ADDENDUM NO. 3

Client: City of Elwood
Municipal Building Renovation

Issue Date: November 2, 2026

SHEET NUMBER:
M101B

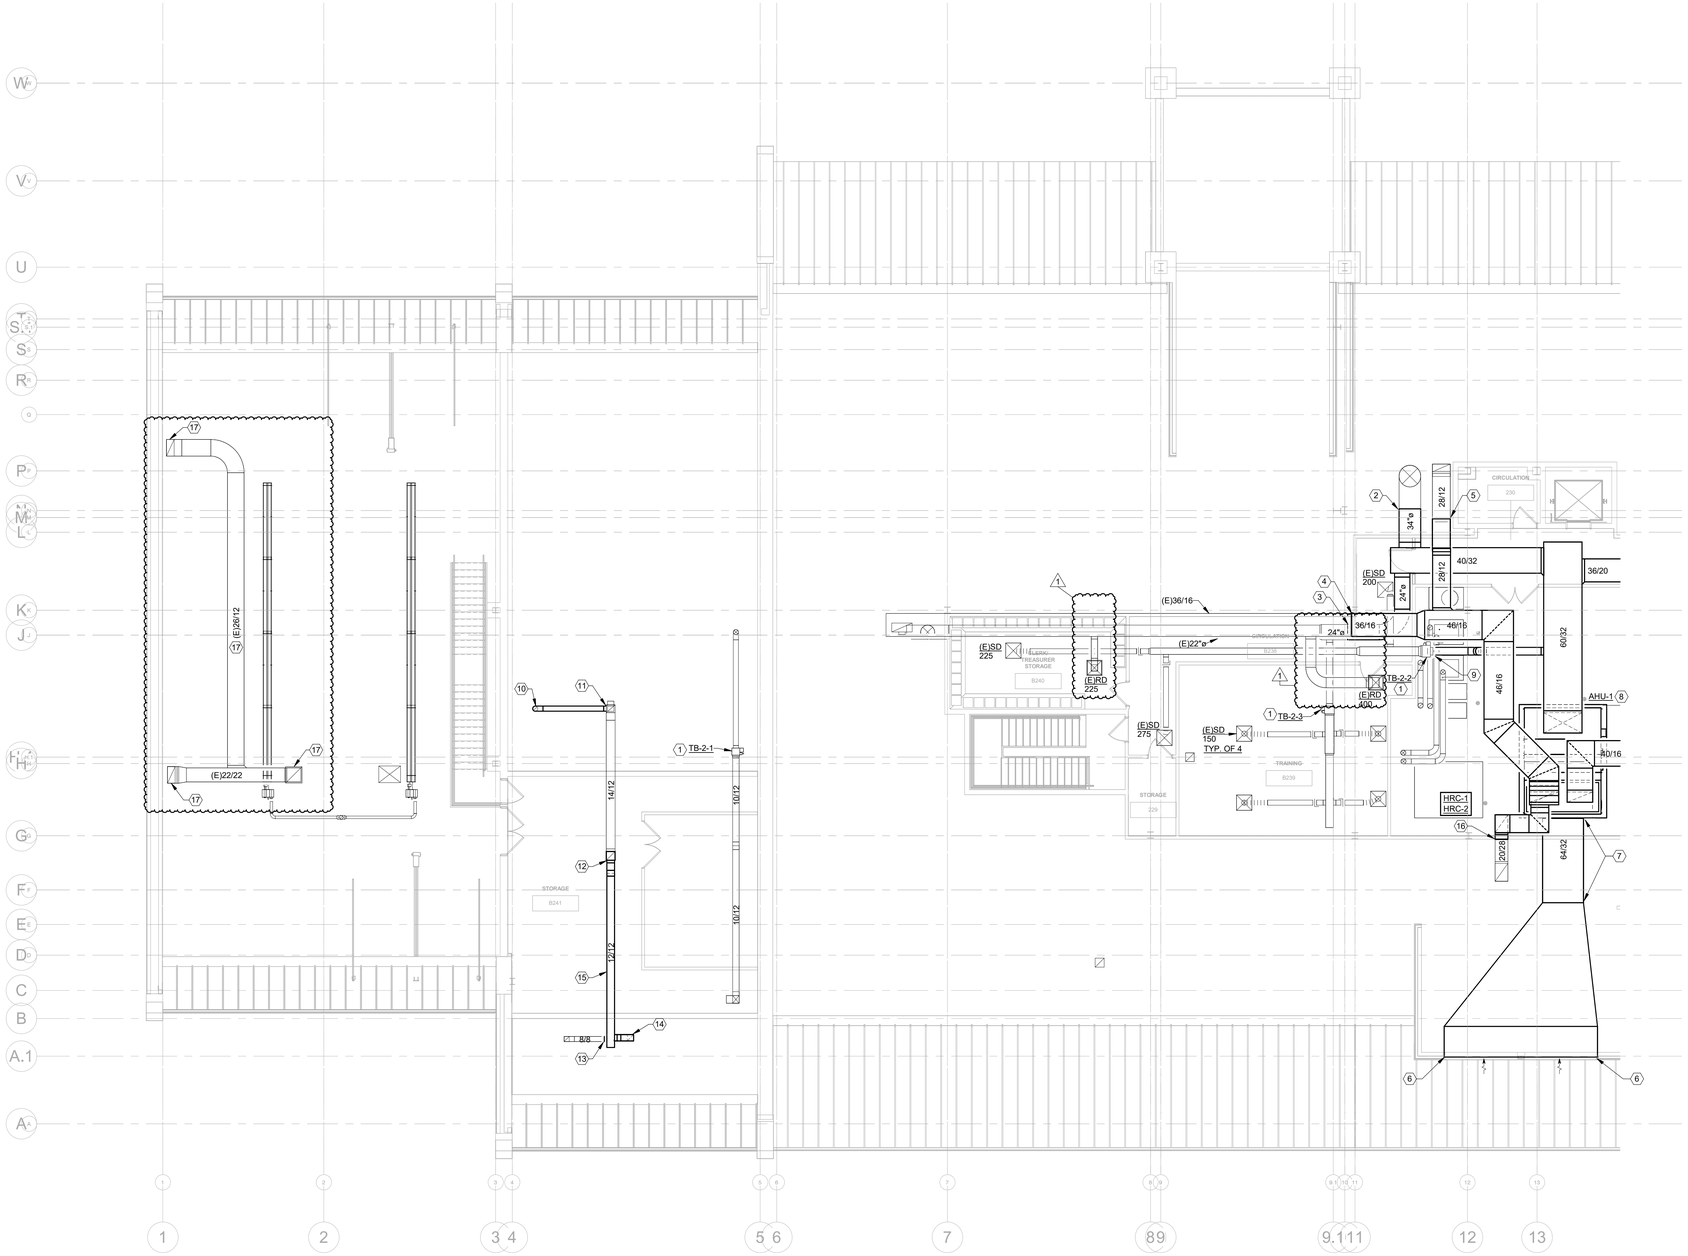
16. **Sheet No. M101B – 1ST FL Plan Mechanical – Area B**

SHEET NUMBER:
M102A

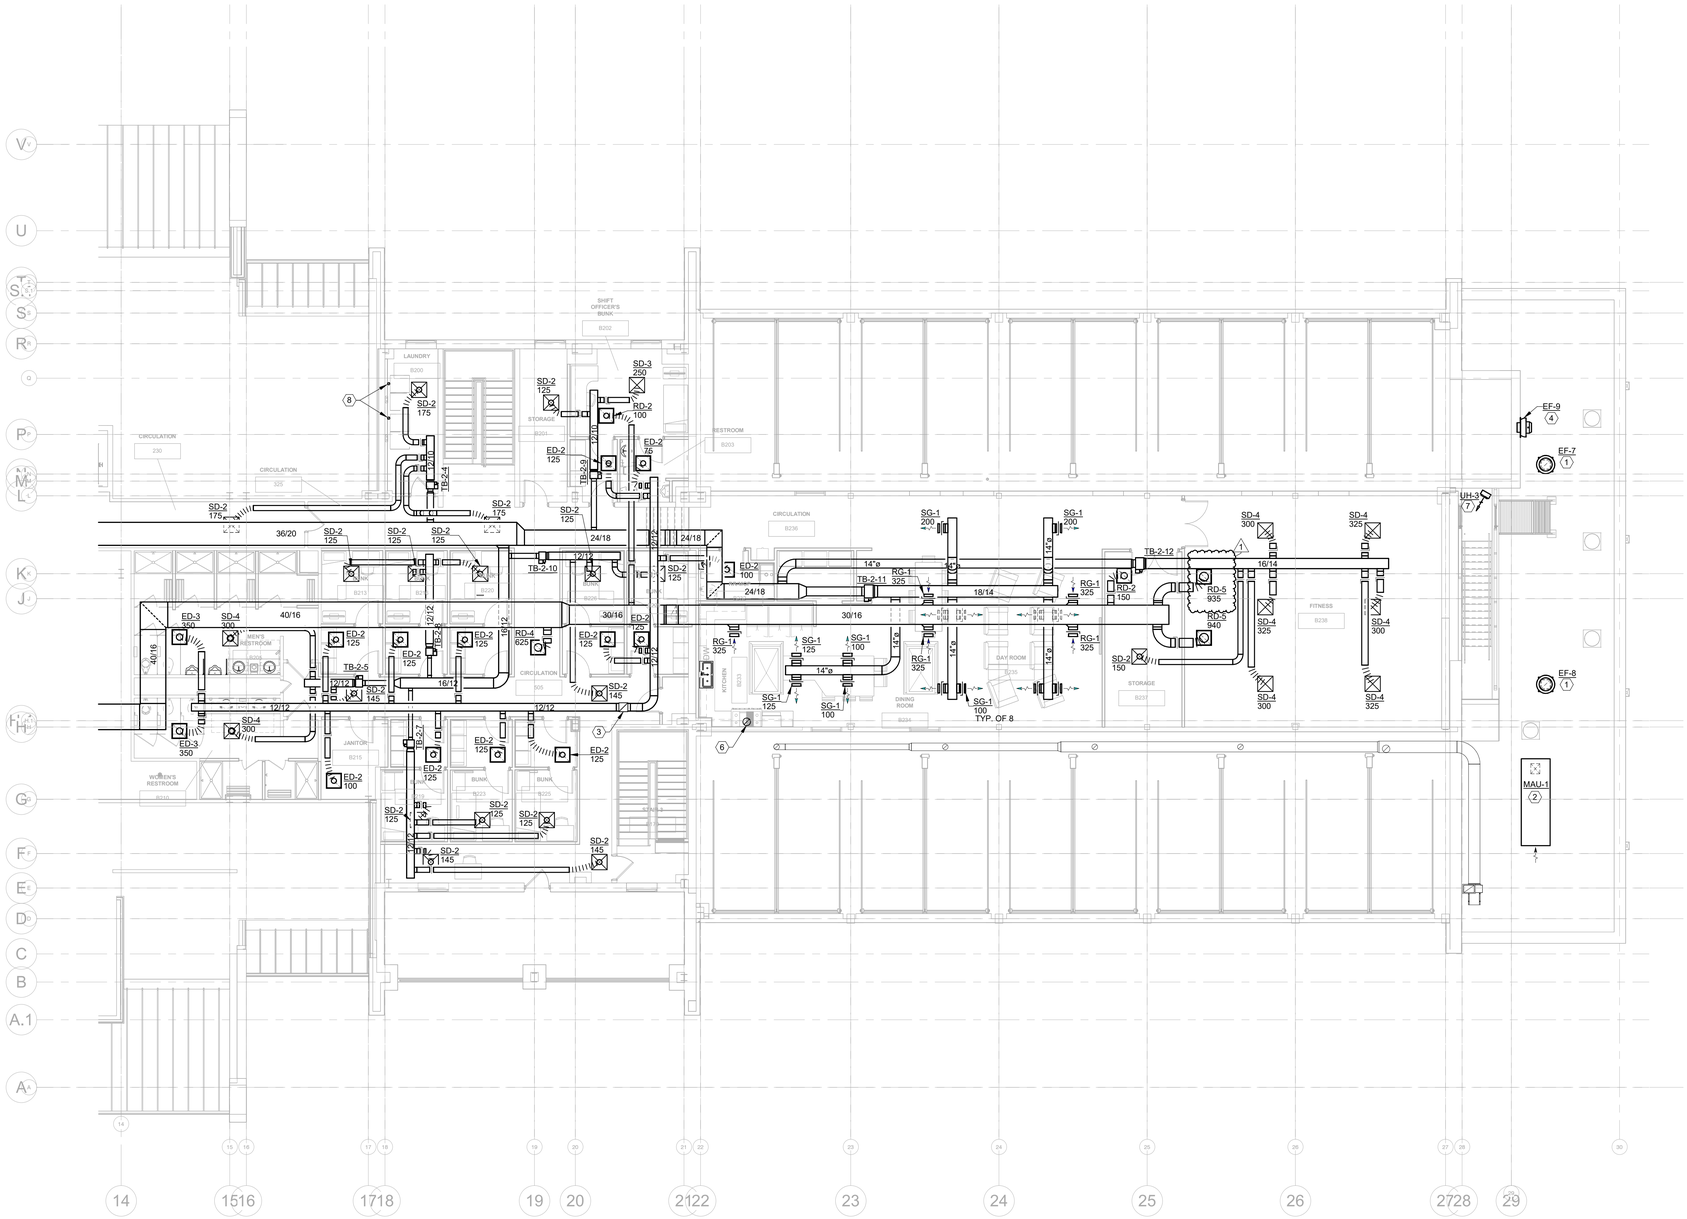
17. **Sheet No. M102A – 2ND FL Plan Mechanical – Area A**

a. Added note 17 for replacing Sallyport exhaust duct.

SHEET NUMBER:
M102B

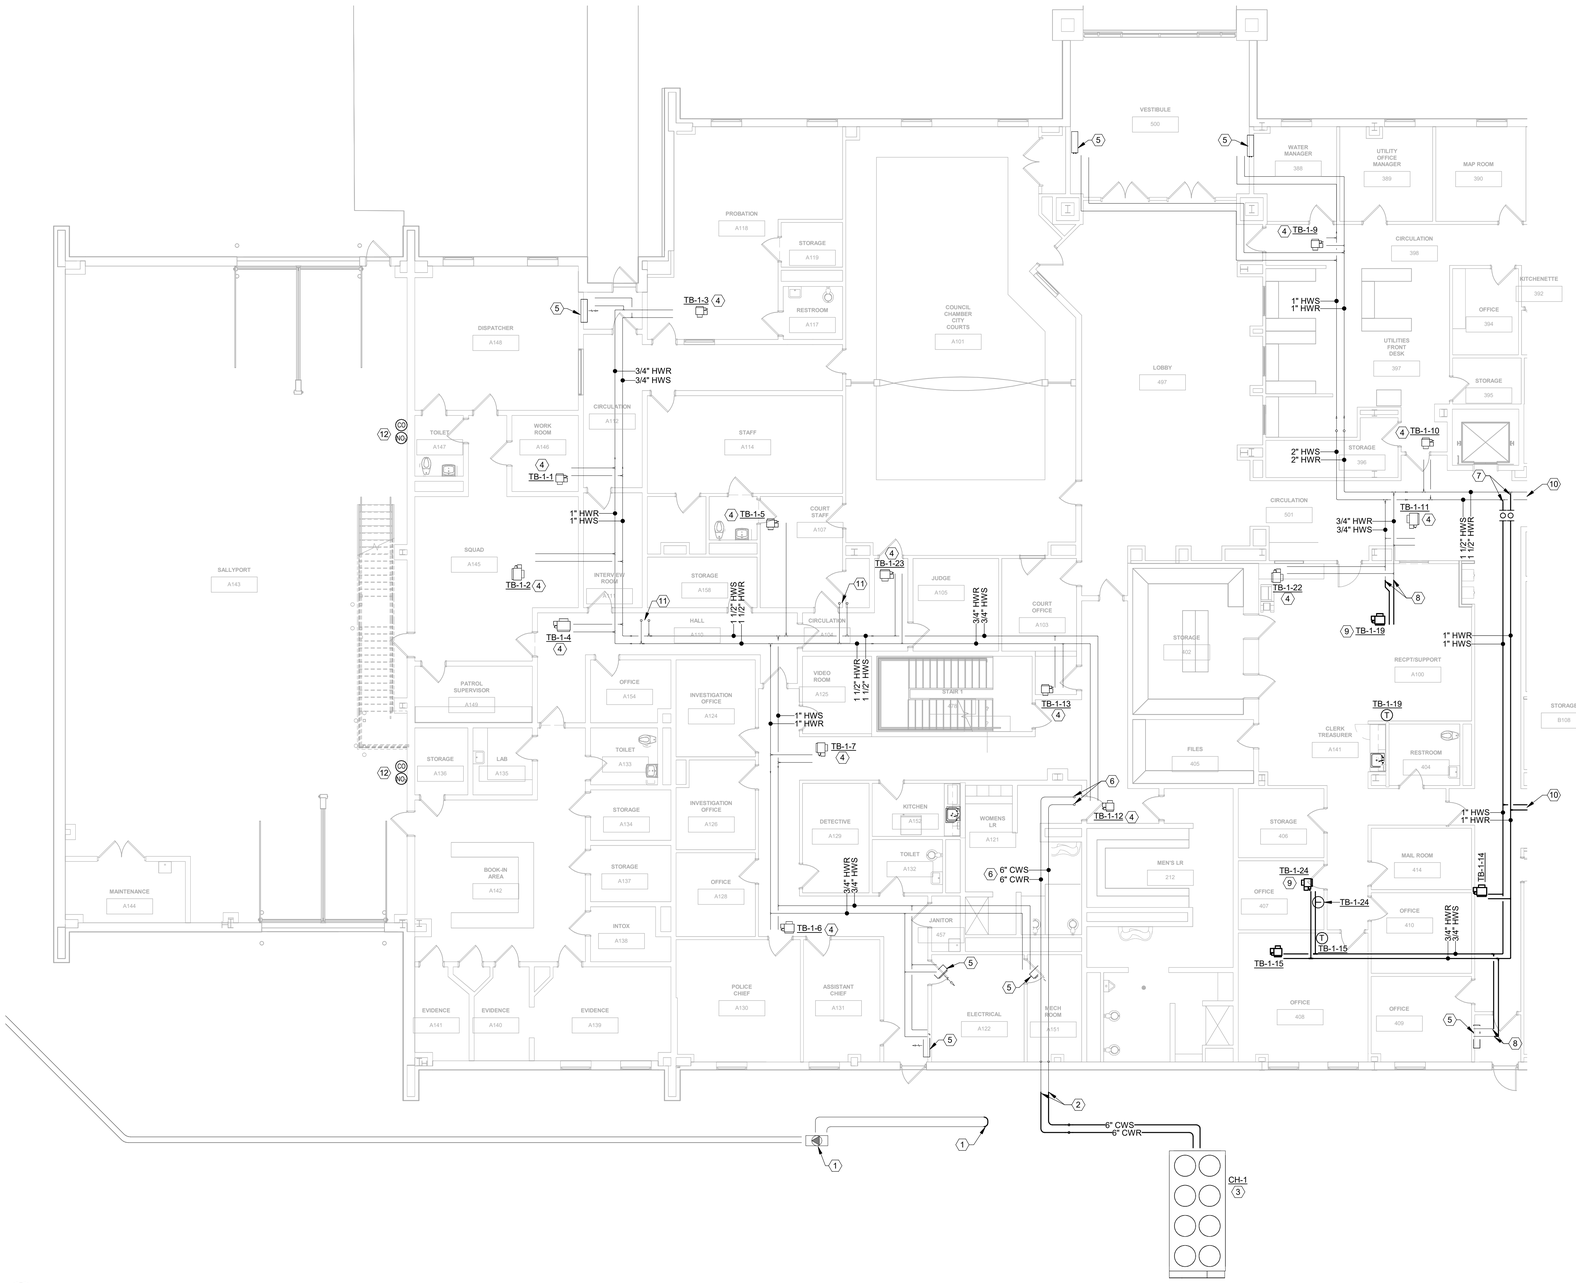
18. **Sheet No. M102B – 2ND FL Plan Mechanical – Area B**

SHEET NUMBER:
M201A

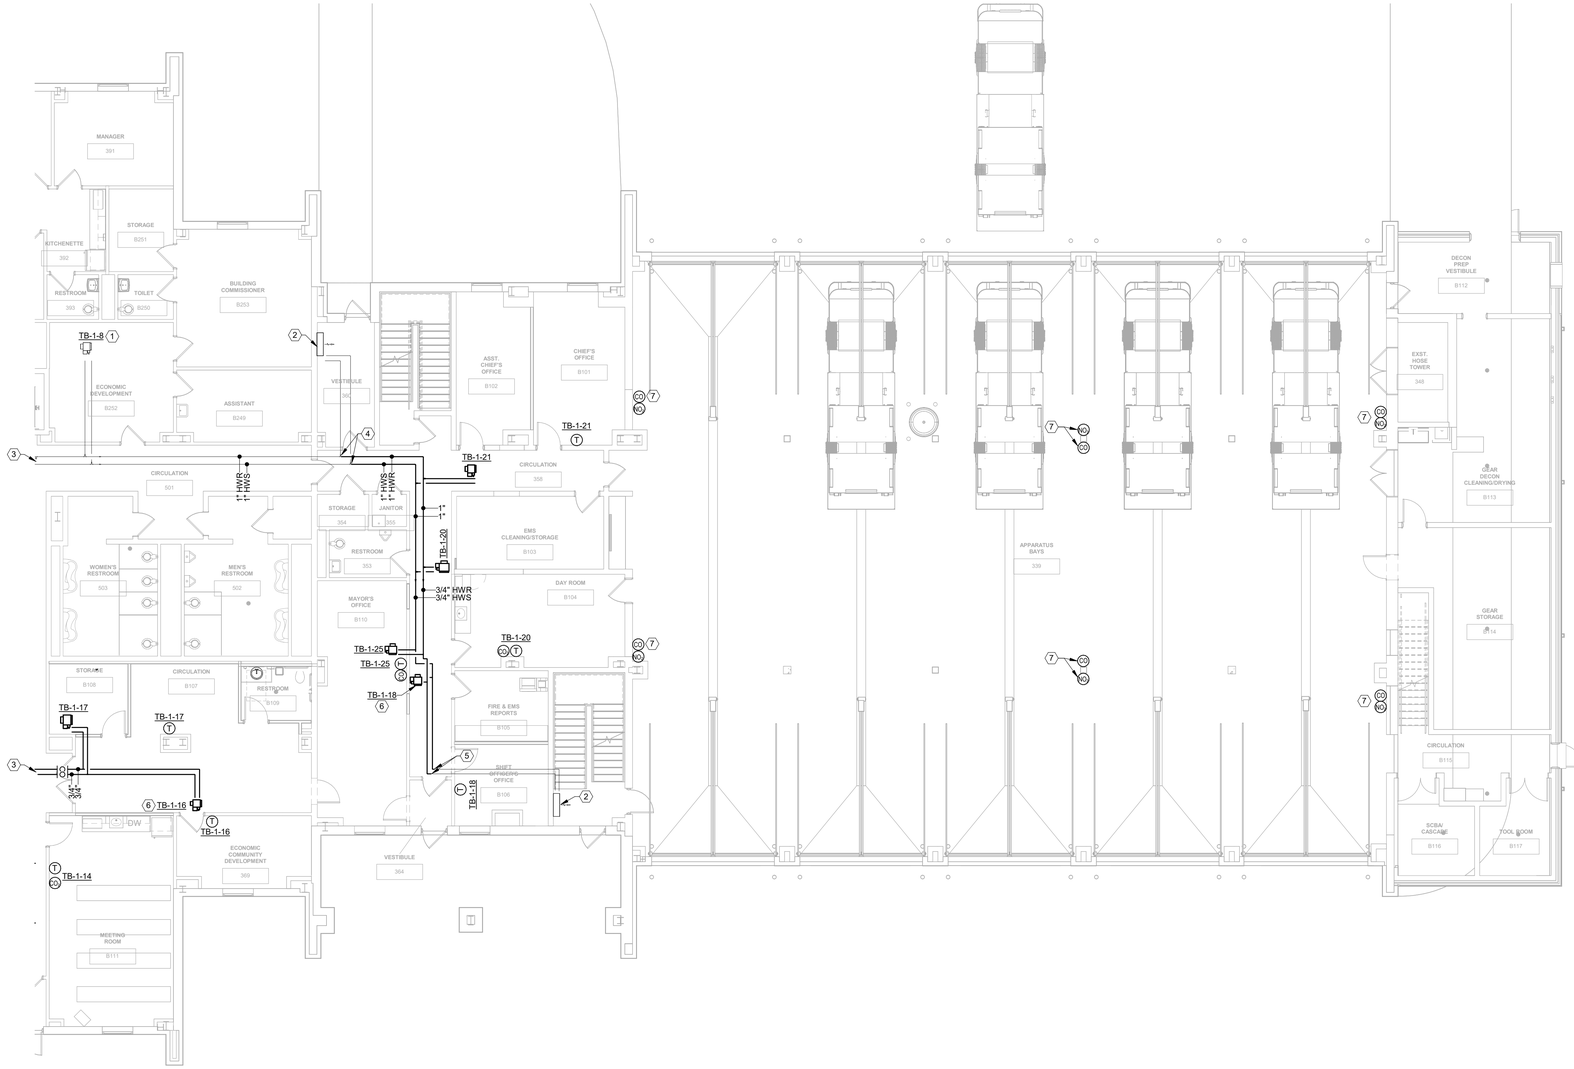
19. **Sheet No. M201A – 1ST FL Plan Mechanical Piping – Area A**

a. Modified note 12 for vehicle exhaust sensors.

SHEET NUMBER:
M201B

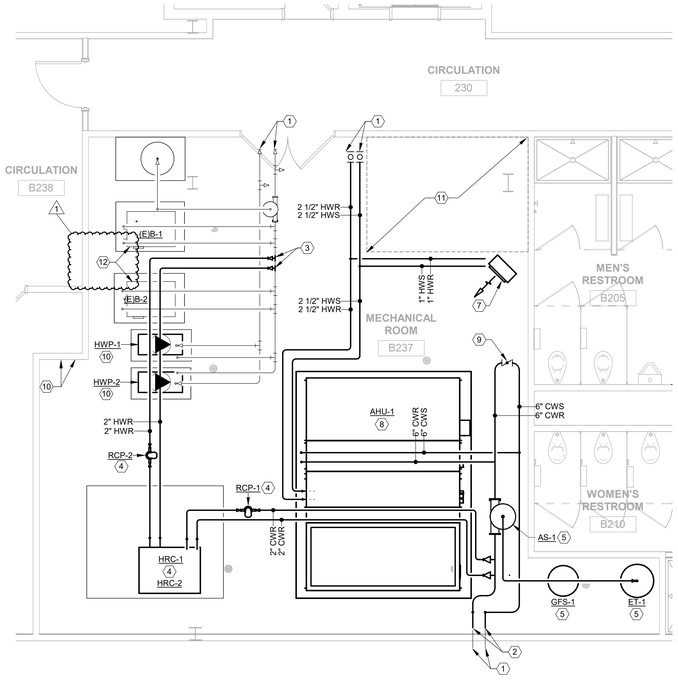
20. **Sheet No. M201B – 1ST FL Plan Mechanical Piping – Area B**

a. Modified note 7 for vehicle exhaust sensors.

SHEET NUMBER:
M701

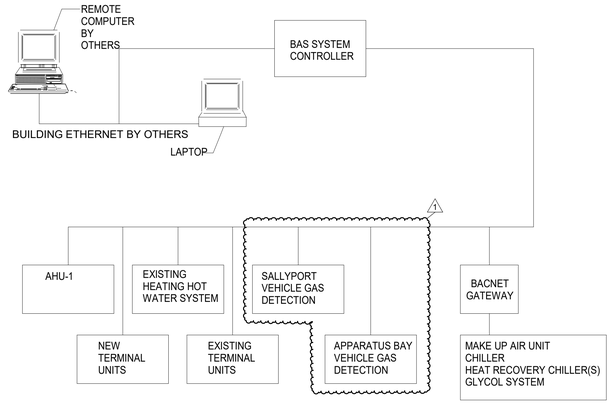
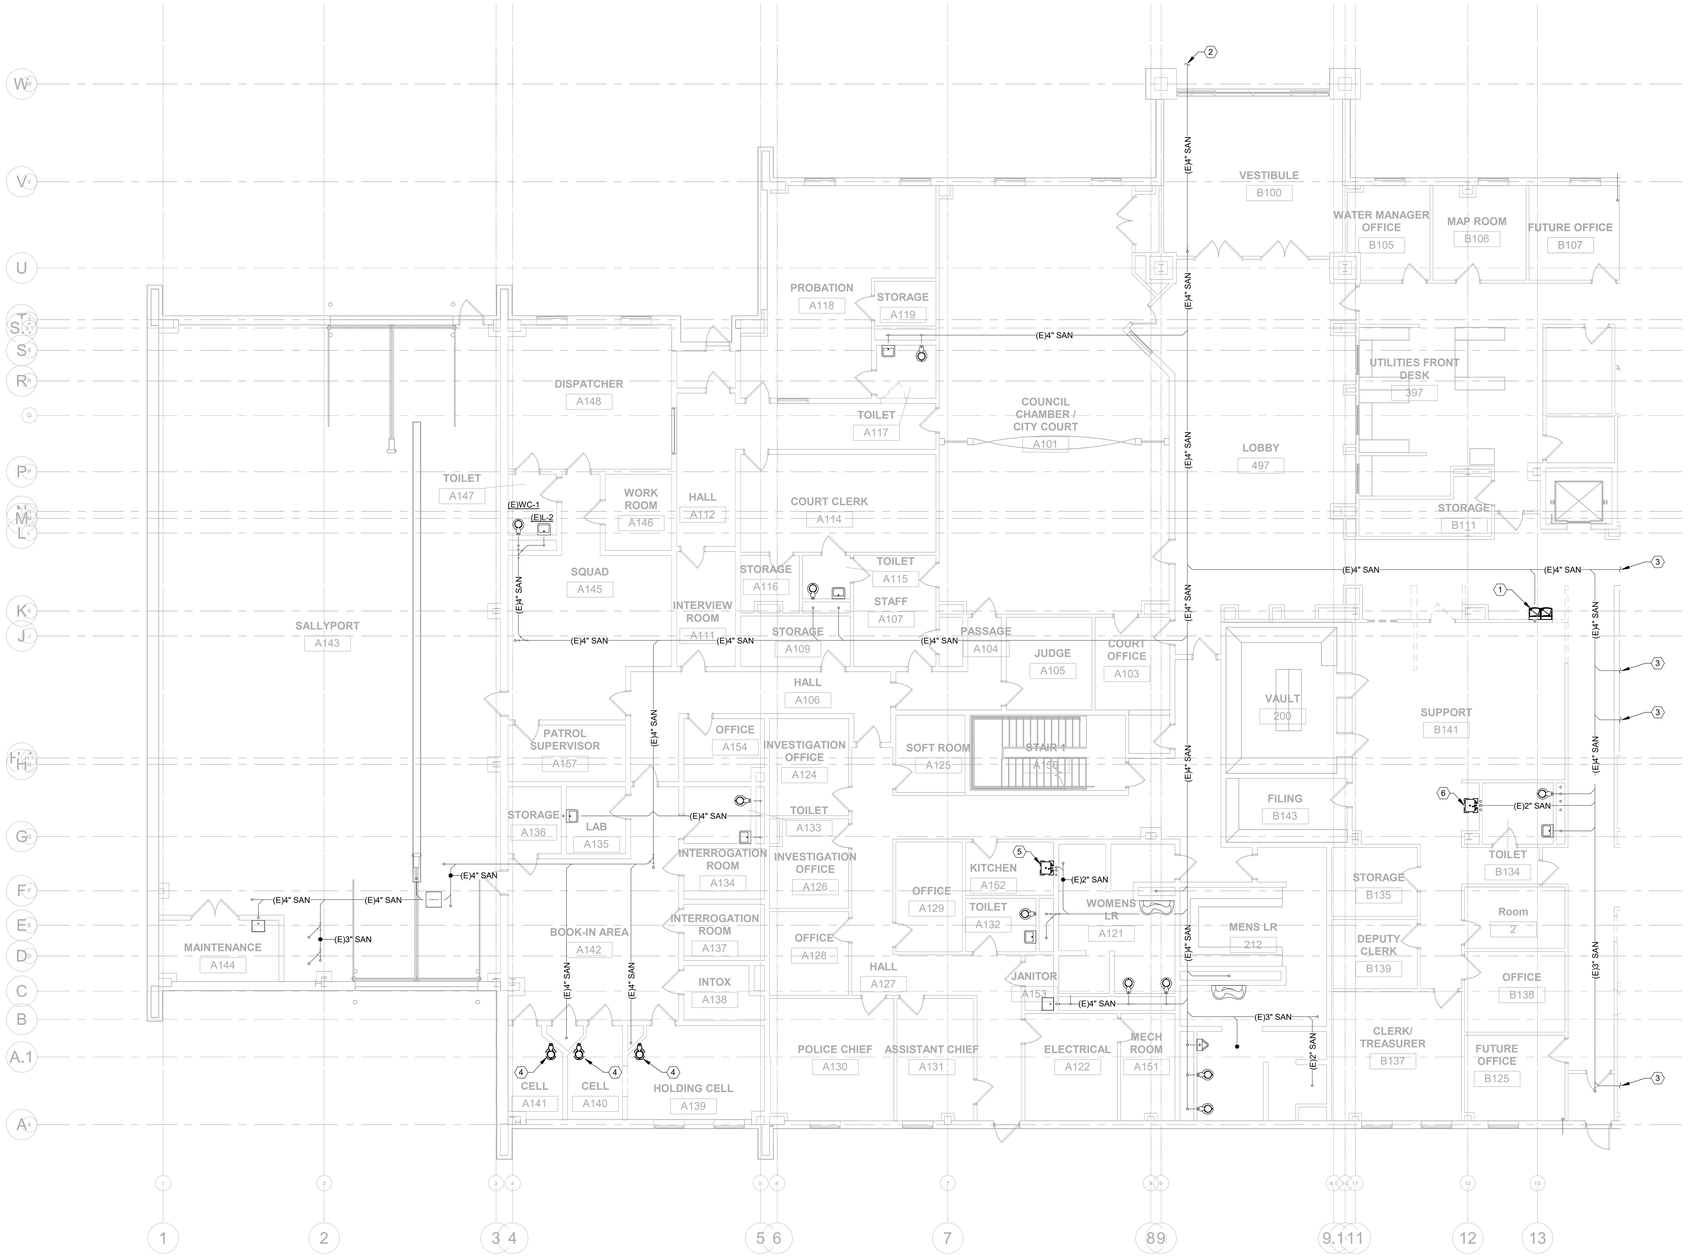
23. **Sheet No. M701 – Sequence of Operations – Mechanical**

a. Added Sallyport and Apparatus Bay vehicle exhaust sensors to BAS
b. Added control sequence for vehicle exhaust sensors.
